**RE: Subgrade Inspection for Lot # 28 Creekside at Raintree – 4412 SW Nautilus Pl
Lee's Summit, MO 66082 – Permit # PRRES20201532**

On June 22, 2020, a special inspection was performed by Residential Engineering Services, LLC (R.E.S.) at the above referenced property. The purpose of this inspection was to determine structural adequacy of the existing soil for construction of concrete foundation.

SPREAD FOOTING
DETAIL
N.T.S.

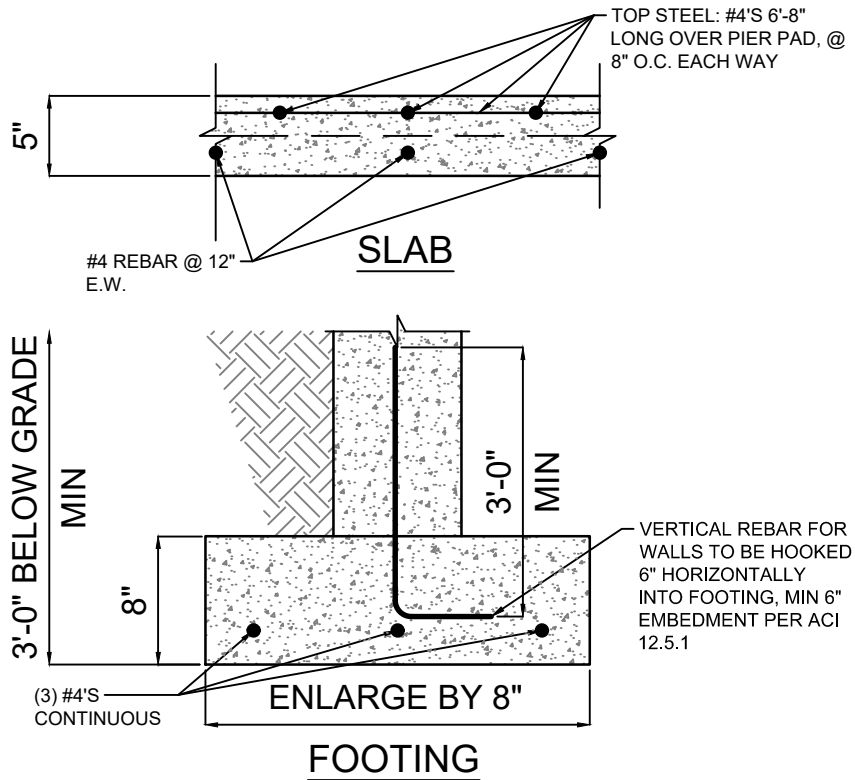
- The soils observed at footing elevation were silty clay; varying from light-dark brown; median-high plasticity and slightly moist.
- Probes and penetrometer readings indicated that the soils do not have sufficient bearing capacity for the loads applied by foundation per permit plans.

- RES recommends that the footings in the north (front) and west (right) area of the lot be enlarged to 24"x8" with three (3) #4 rebar continuous (see attached specifications)
- Basement and garage pier pads shall be enlarged a minimum of 6" each way (i.e existing 30"x30" shall be enlarged to 36"x36", etc.) (see attached specifications)
